**CITY OF BLOOMINGTON
BOARD OF ZONING APPEALS (Hybrid Meeting)**

BLOOMINGTON BOARD OF ZONING APPEALS CASE #: V-43-23 / VAR2023-11-0018
STAFF REPORT

Location: 123 S. Kingston Drive

REQUEST: Variances from standards for driveways and access, vehicle parking location and design, bicycle parking location and design, parking lot landscaping, and street trees to allow the reuse of an existing building for a “retail sales, large” use in the Mixed Use Corridor (MC) zoning district

designed by: JSF
drawn by: MSF
checked by: MSF
sheet no.: 0301
project no.: 402350

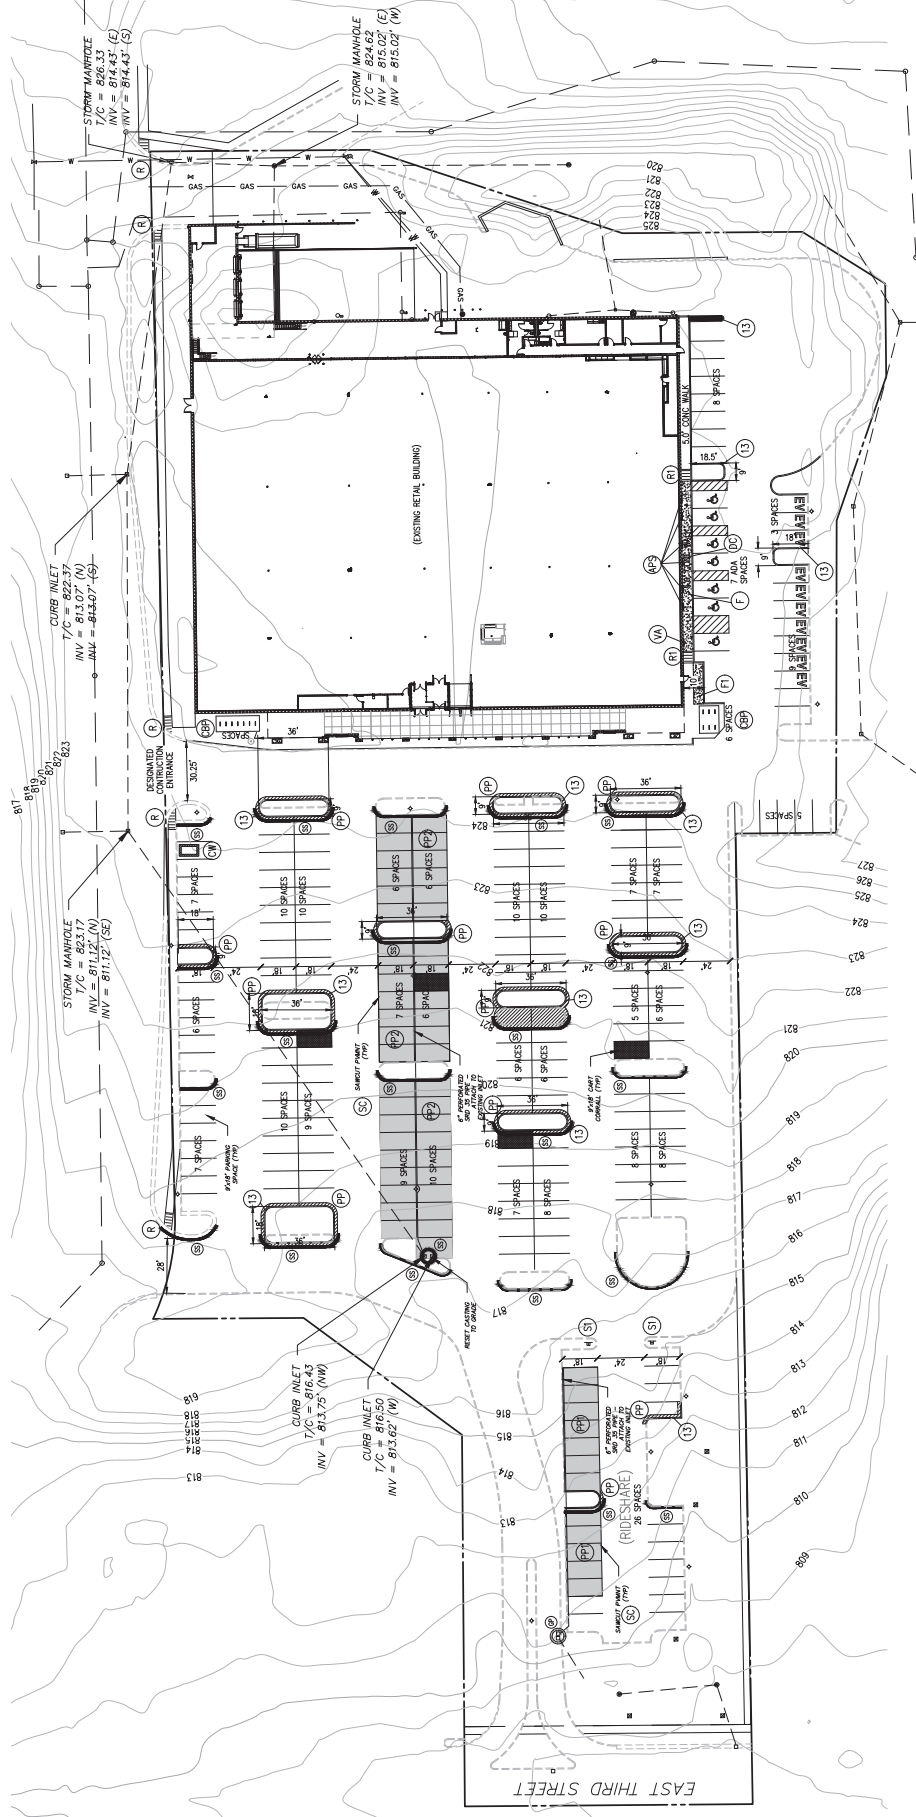
The petitioner has submitted a site plan that does not comply with staff's guidance for the applicable UDO standard. The proposed site plan does not provide gaps in the curbing of any of the existing or new parking lot islands, and does not lower the level of any of the existing or new islands below the parking lot surface. The petitioner has requested a variance from this standard in order to allow the parking lot islands as shown in the proposed site plan.

The submitted site plan labels the bicycle parking areas as "CBP" which the site legend identifies as "Covered Bike Parking". The site plan as submitted is therefore compliant with this standard. However, the petitioner's statement clearly requests a variance to allow uncovered bicycle parking and the petitioner has verbally confirmed to staff that they wish to request this variance.

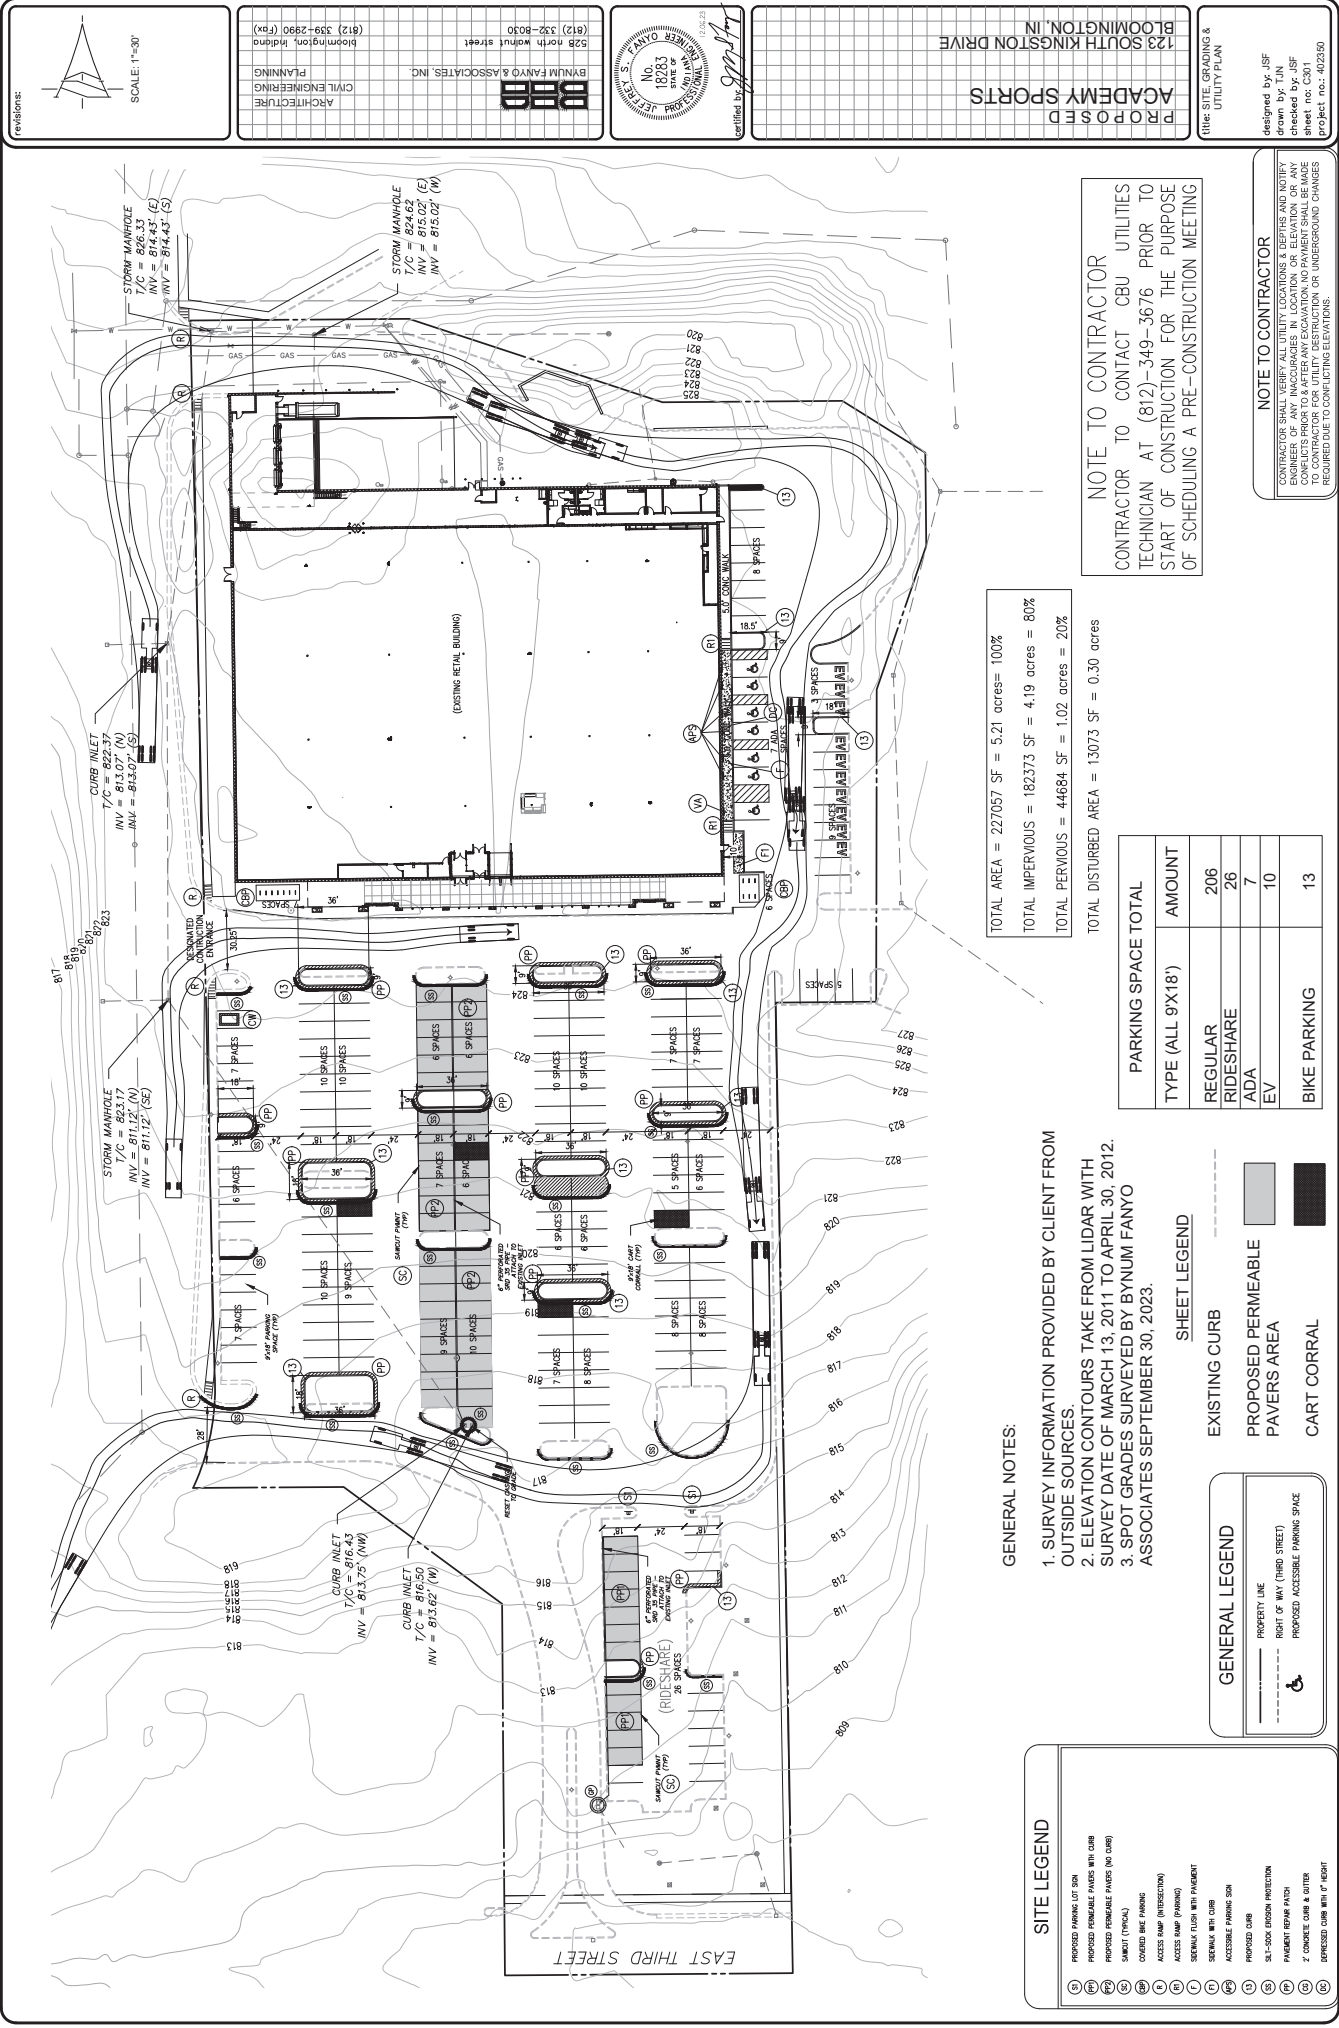
- I don't see the additional context I requested around the access points of Kingston (curbs, pavement markings, etc.). It is hard to evaluate a turning movement analysis without knowing the context of the facility it is entering/exiting (e.g., I need information on both sides of the road). Am I missing something?
- Is the 'island' within the southeast corner of the site's parking lot be mountable? It appears the proposed design vehicle will struggle to maneuver the site but I'm not certain of the details of this design element.
- The access easement I'm looking at appears to be on the adjacent parcel, not the subject site. Am I looking at that correctly?

- Can you update the drawing that shows the truck movements so that it reflects a continuous route through the site? I would have assumed trucks would use the northernmost access point and potentially one of the others. I also want to make sure the proposed interior of the site can accommodate trucks through the proposed route.
- Can the drawing be updated to provide some additional context for Kingston? At this point all I see are general grades but what is necessary for this evaluation are things like the roadway's curbs/edge of pavement and pavement markings in proximity to the access points.

Attached is the revised large truck movement plan. For further clarification regarding the 3 Kingston Drive entrances, the Academy Sports intended semi-truck movement is to enter the northern most Kingston Drive entrance, then back into the 2 semi docks and exiting as shown on the revised attached drawing the Southern most Kingston Drive entrance. Regarding the middle Kingston Drive entrance, it can and does serve an occasional semi-truck entering or exiting that entrance but can only circulate thru the adjacent Kingston Shoppes property located and adjoining east of the subject property and thereafter entering and exiting thru the northern most Kingston Drive entrance-way. This middle Kingston Drive truck entrance and exit way are served by an easement recorded February 22, 2007 attached hereto. The attached Kingston Shoppes site plan details the shared northern most Kingston Drive entrance with the subject property."

There have been a couple of comments from you regarding this subject project. Please see attached for existing driveway widths labeled along with a truck turning movement for the deliveries. We believe this shows the need for keeping both driveway widths as existing.

Diagram of parking lot bumpouts, islands, and endcaps by type for compliance with UDO section 20.04.080(h)(2)(D)

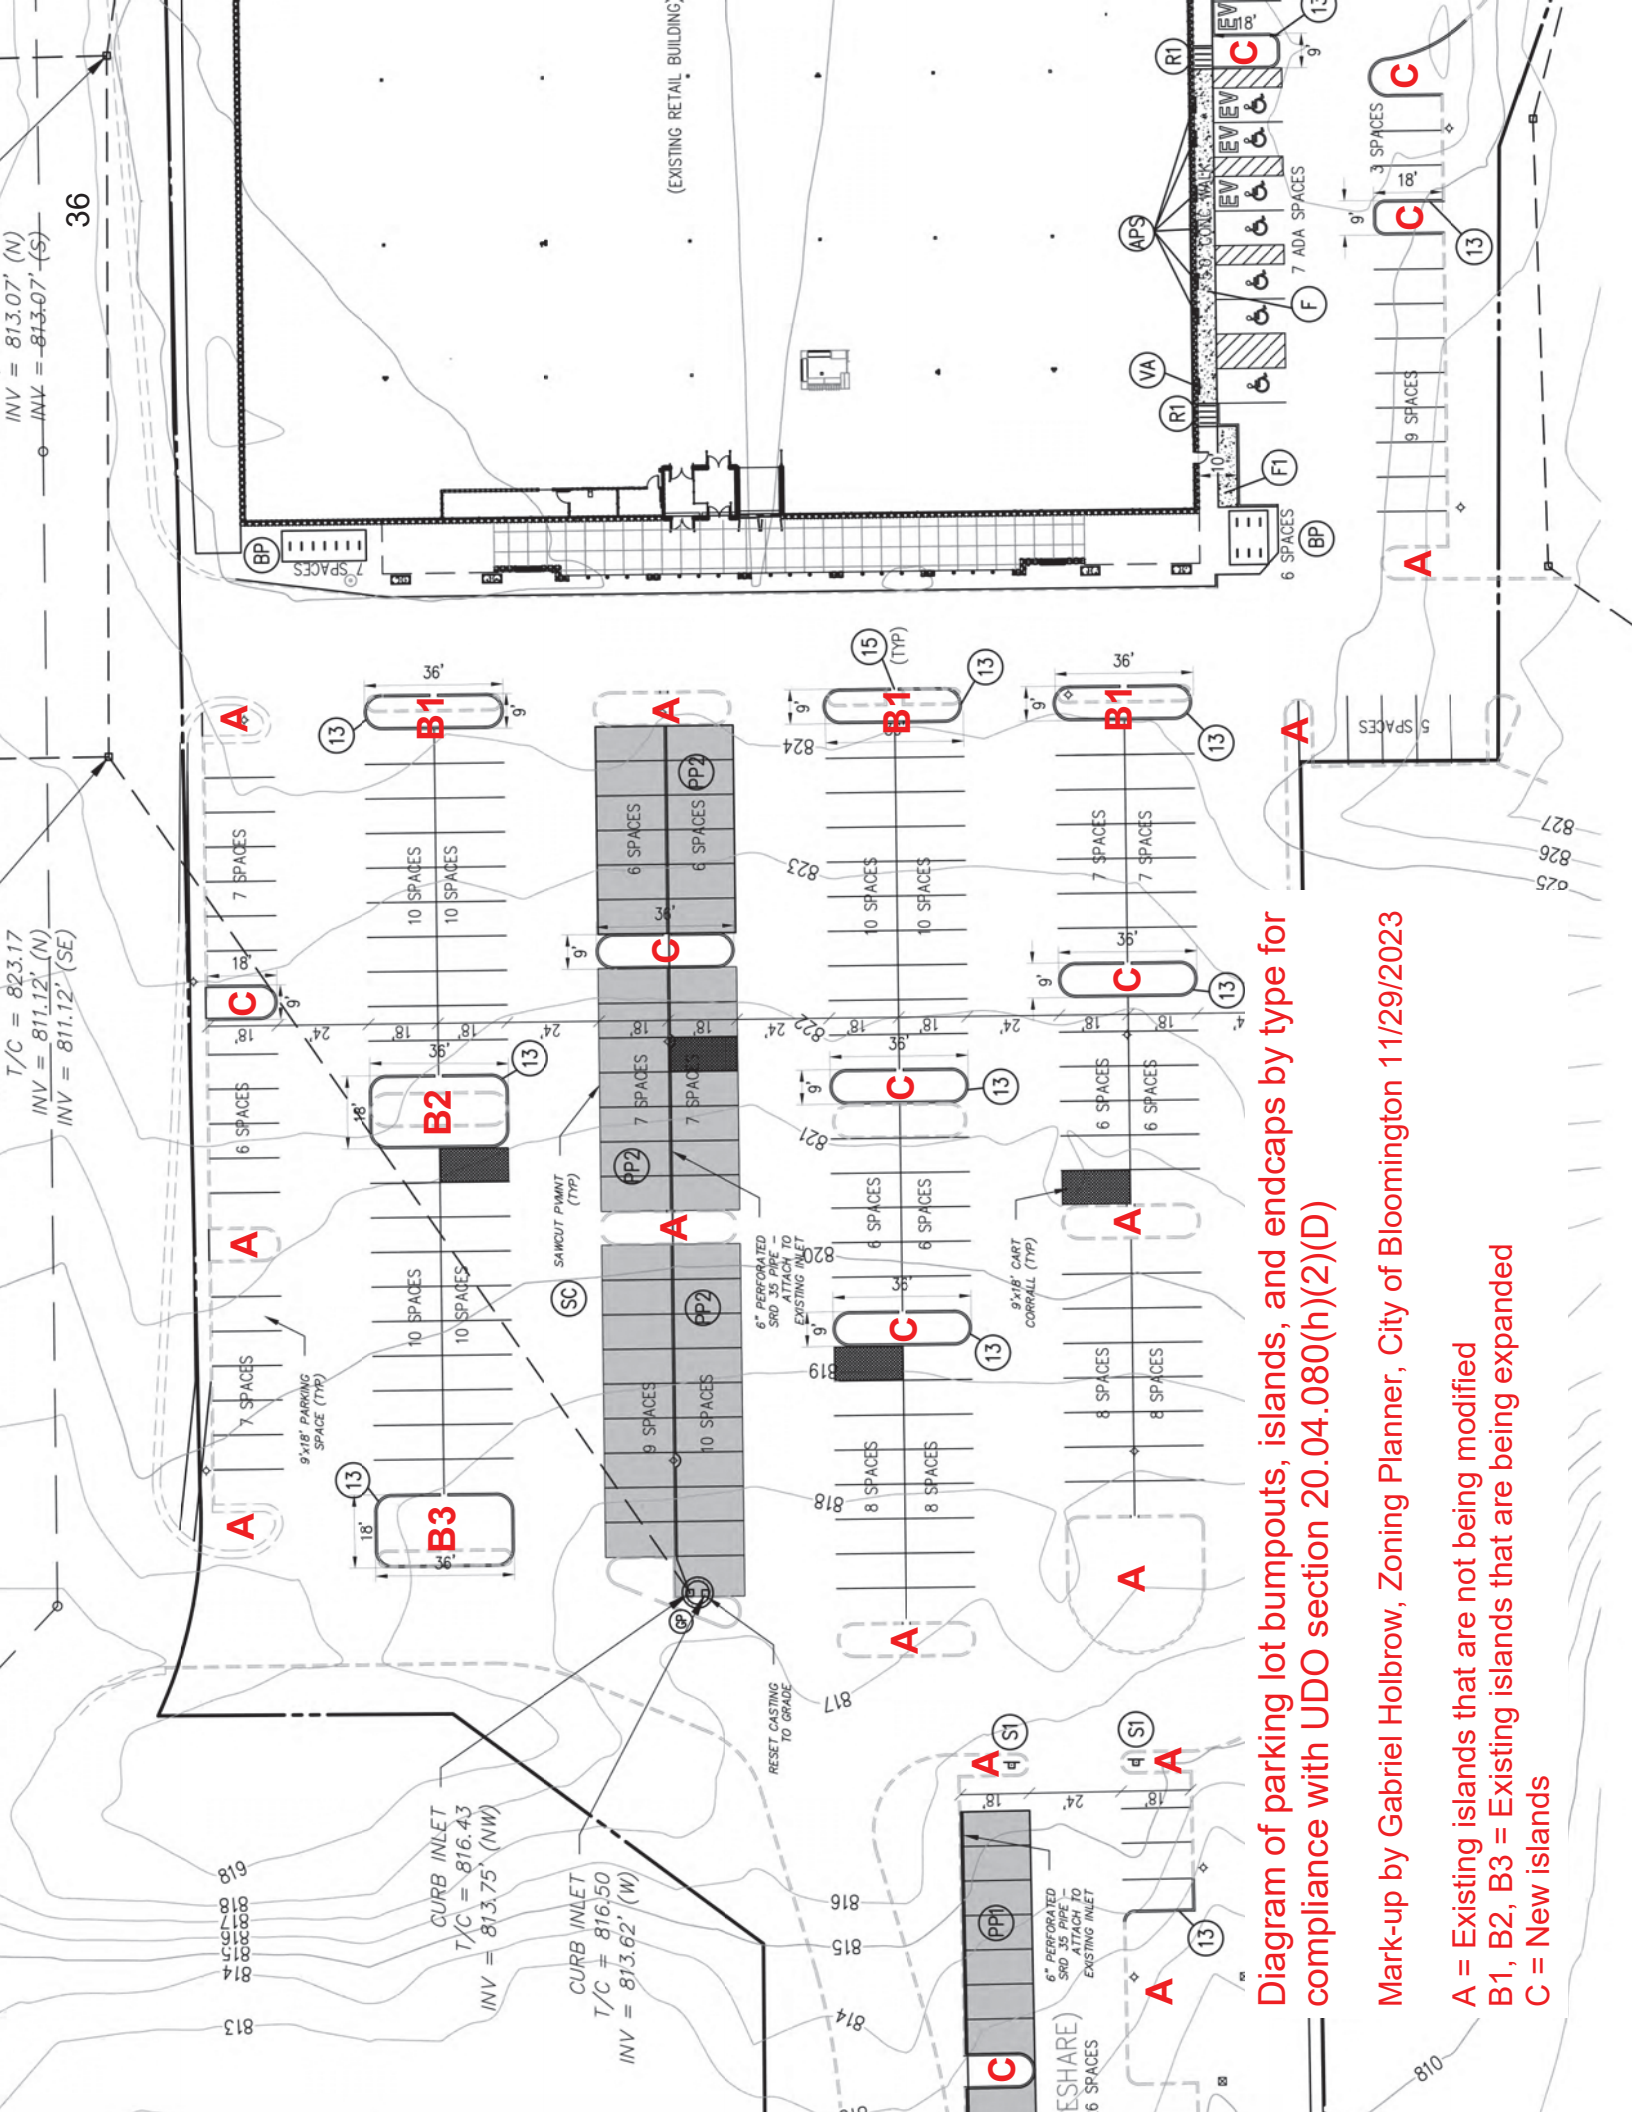
Because the proposed parking lot design includes existing bumpouts, islands, and endcaps (hereafter "islands" for brevity) that are not being modified, existing islands that are being expanded, and new islands, staff has provided guidance to the petitioner on the specific application of this UDO standard to this parking lot, including a diagram of the parking lot

- Existing islands that are not being modified (marked as A in the diagram): Must have at least one cut in the curb on the uphill side to allow water to filter into the soil inside the island. The existing ground level (elevation) can remain, even if it is above the level of the parking lot. If there is concern that sediment (soil, mulch) from the raised island bed may wash out of the required curb cut, the plans should call for a permanent mesh screen (not plastic) or similar in the cut to hold in the sediment but allow water to filter in. Staff is open to discussion about the exact format of such mesh or similar, based on practical engineering considerations.

- New islands (marked as C in the diagram): Must fully comply with the standard, including an interior ground level that is lower than the parking lot surface and at least one cut in the curb on the uphill side.

- Existing islands that are being modified fall into three categories (marked as B1, B2, and B3 in the diagram): B1 are three existing islands that are being expanded on the downhill side, and so should be treated the same as type A; namely curb cut required but lowered level not required. B2 is one existing island that is being expanded narrowly on both the uphill and downhill sides; curb cut required, and lowered elevation in the uphill (northern) expanded area required unless the design engineer or site contractor determines that the expanded area is too narrow to fit in a workable grade to lower any meaningful part of the island--that is, if they determine that a lowered elevation is not reasonable based on practical engineering considerations. B3 is one existing island that is being significantly expanded on the uphill side, and so should be treated similarly to type C; namely curb cut required and lowered level required for the expanded portion (the existing ground level on the south side may remain).
